RE: Data Response, Set 1D (Optimization)
Ivanpah Solar Electric Generating System (07-AFC-5)

Ivanpah Solar Electric Generating System (ISEGS)

Data Response, Set 1D

**(Response to Data Requests: Project Description, Air Quality,
Biological Resources, Land Use, Soil & Water, and Visual
Resources)**

FIGURE DR4-1
IVANPAH 1 SOLAR FIELD LAYOUT
IVANPAH SOLAR ELECTRIC GENERATING SYSTEM

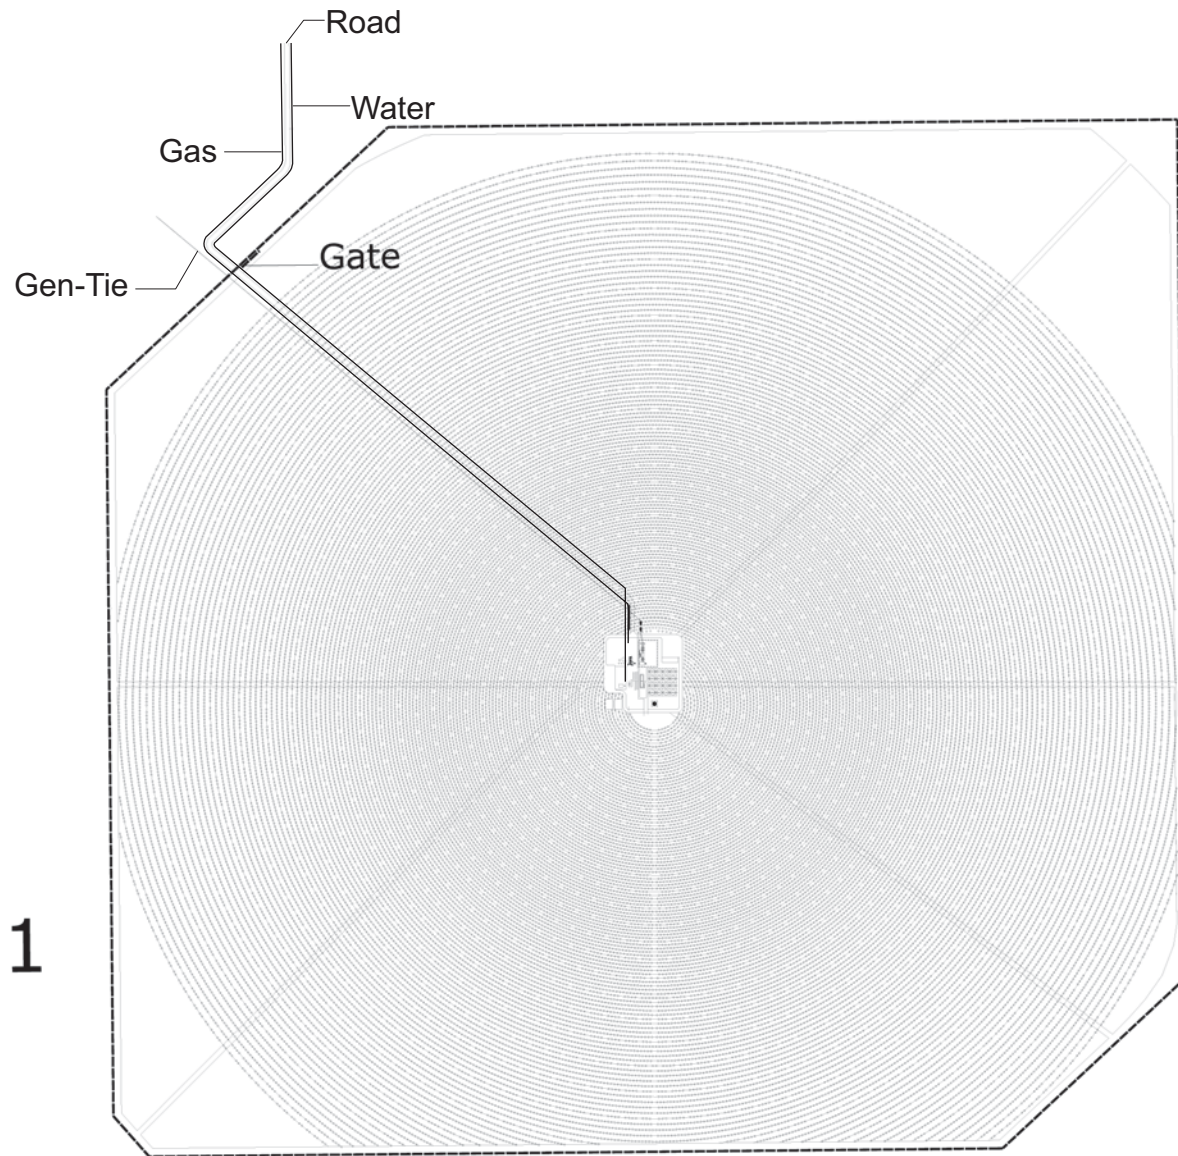
The Applicant has been able to reduce the number of power towers in both Ivanpah 1 and Ivanpah 2 to just one solar tower (at the power block), instead of three power tower receivers and one solar reheater (see Figures DR4-1 and 2). The 200 MW plant, Ivanpah 3, would still employ four power tower receivers and one solar reheater (at the power block). The trade off for the increased efficiency of the double-hung heliostats and the reduced number of towers is that the remaining towers need to be taller to accommodate the double hung mirror configuration and more distant mirrors. The increased height of the mirrors requires that the height of the receivers (i.e., the power towers) be increased so that the heliostats are able to reflect the sunlight over the top of the heliostat row in front of it.

For the Ivanpah 1 and 2 configuration, the power tower support structures would increase from 262 feet high (80 meters) to 393 feet high (~120 meters). The boiler/superheater panel height would be 66 feet tall (~20 meters) including the added height for upper steam drum and protective ceramic insulation panels. Overall, the tower height would be 459 feet tall (~140 meters), consistent with Ivanpah 3. In addition, FAA-required lighting and a lightening pole will extend above the top of the towers approximately 5 to 10 feet.

FIGURE DR4-5
APPEARANCE OF SITE AFTER CONSTRUCTION
IVANPAH SOLAR ELECTRIC GENERATING SYSTEM

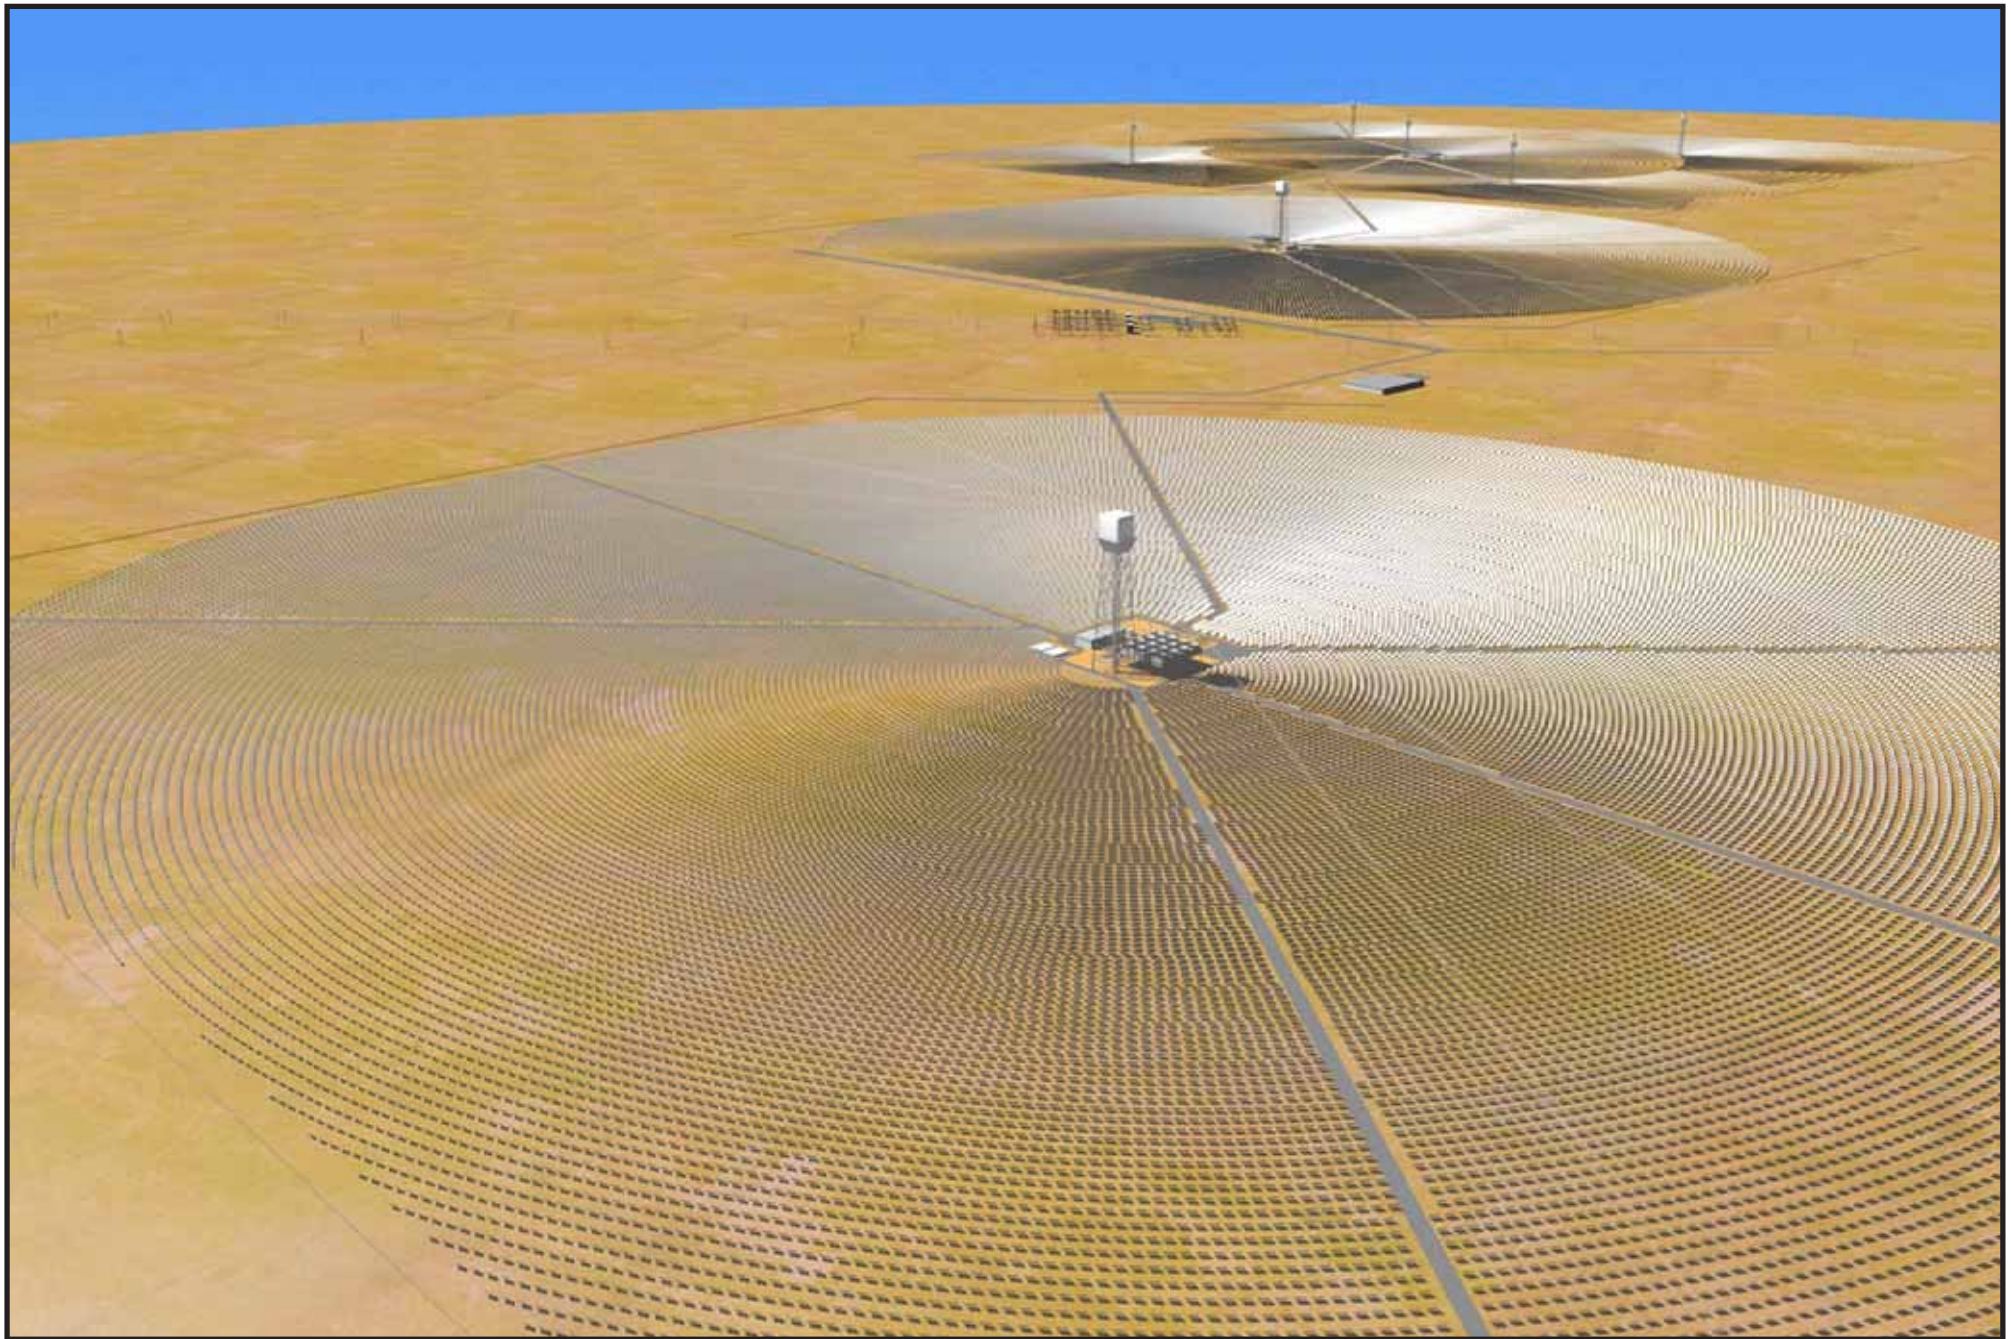
For the Ivanpah 3 configuration, the power tower receivers and solar reheater support structures would remain 459 feet tall (~140 meters). A rendering of the site with the new heliostat and tower configuration is provided as Figure DR4-5. In addition, as a result of these modifications, the heat balance and water balance diagram have been revised. They are provided as Figures DR4-6 and -7, respectively.

FIGURE DR4-8
SITE PLAN AND LINEARS
 IVANPAH SOLAR ELECTRIC GENERATING SYSTEM
 CH2MHILL

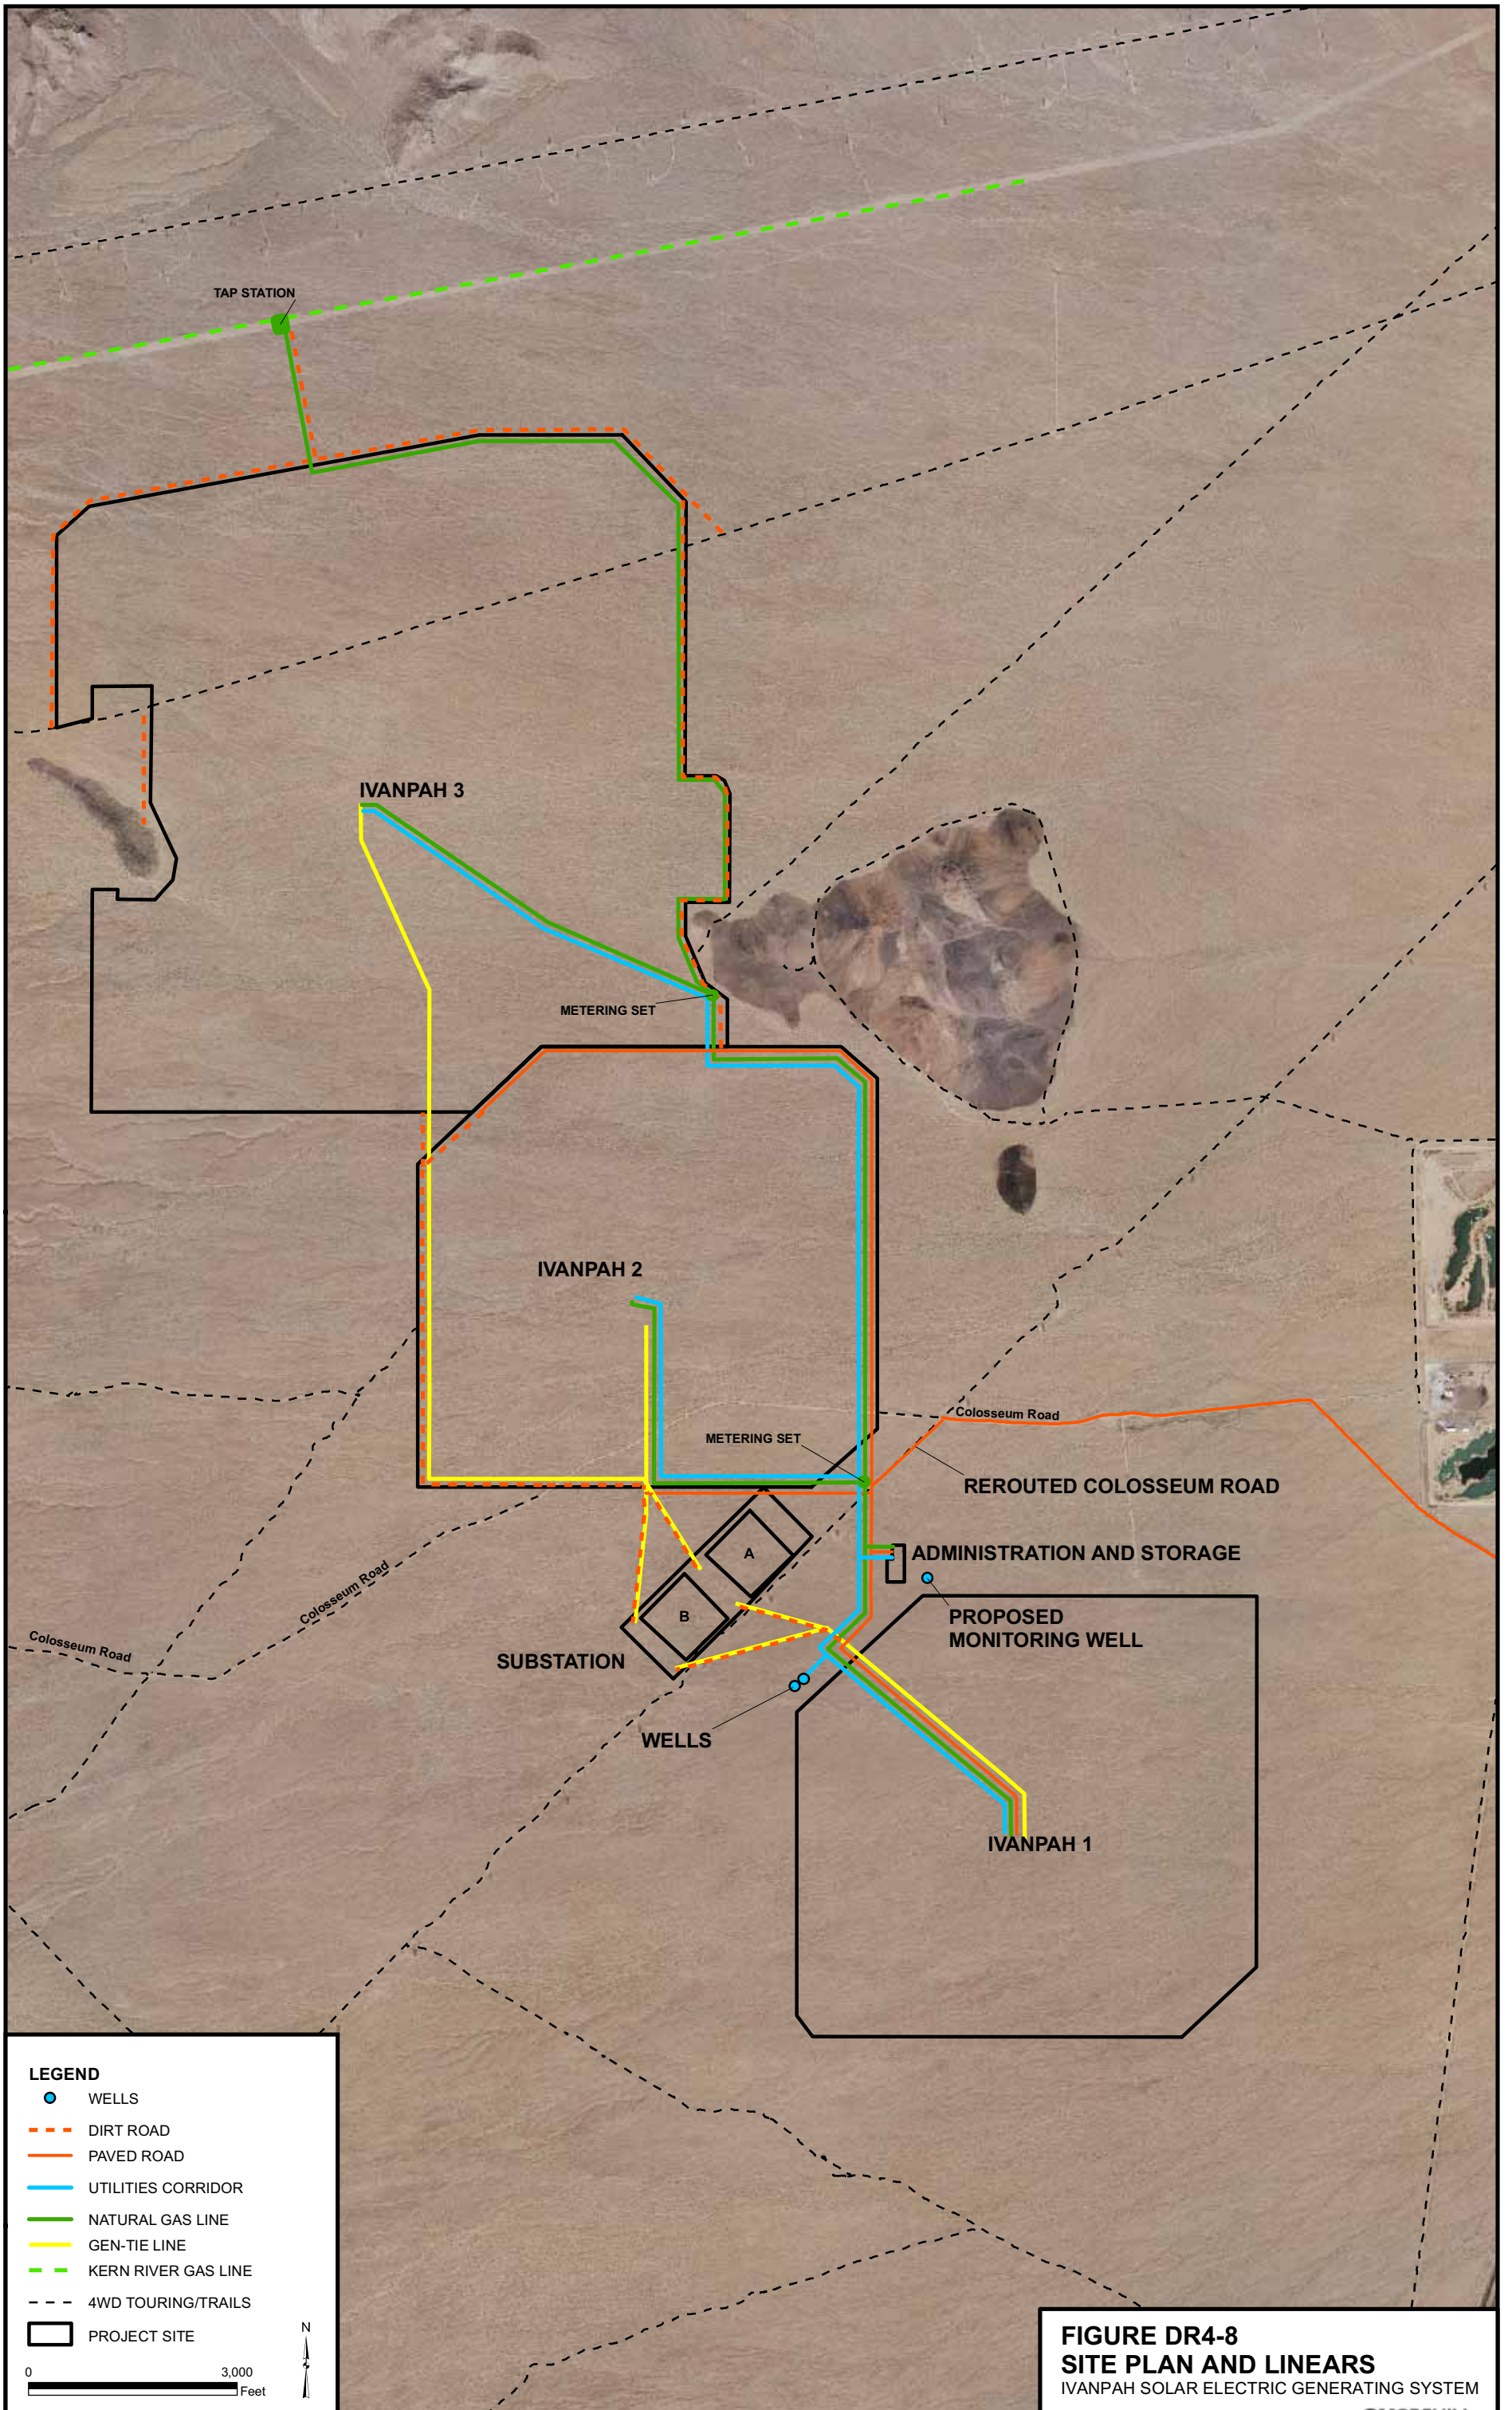
To reduce access roads and land impacts and as part of the optimization process, the water supply wells will be relocated approximately 4,250 feet to the south of their originally planned location to be farther away from the existing golf club wells. In the AFC, the wells were proposed to be located to the east of Ivanpah 2 and west of Colosseum Road. Based on comments received from BLM, it is now proposed that they be located adjacent to Ivanpah 1's northwest corner, which will eliminate the need for a separate access road and move the wells farther away from two existing wells on Colosseum Road. (The proposed wells will be about 1.1 miles from the Colosseum 1 well and about 0.97 miles (5,150 feet) from the Colosseum 2 well. As a result, the water lines from the wells to the 3 sites were also relocated. It is also proposed that a monitoring well be located between the project's supply wells and the two supply wells for the Primm Valley Golf Club. The location of this monitoring well is just southeast of the administration/warehouse building. The water optimization is described in more detail in the revised responses to Data Requests 68, 75, and 76 and the proposed monitoring and supply well locations are shown on Figure DR4-8.

It was determined that Southwest Gas Company would need access to the gas line for service/repair work. To minimize impacts to operating plants, the gas line was re-routed along the west side of Ivanpah 2 and 3 and a dirt road was added to provide the gas company with access. The realigned gas lines are also presented in Figure DR4-8.
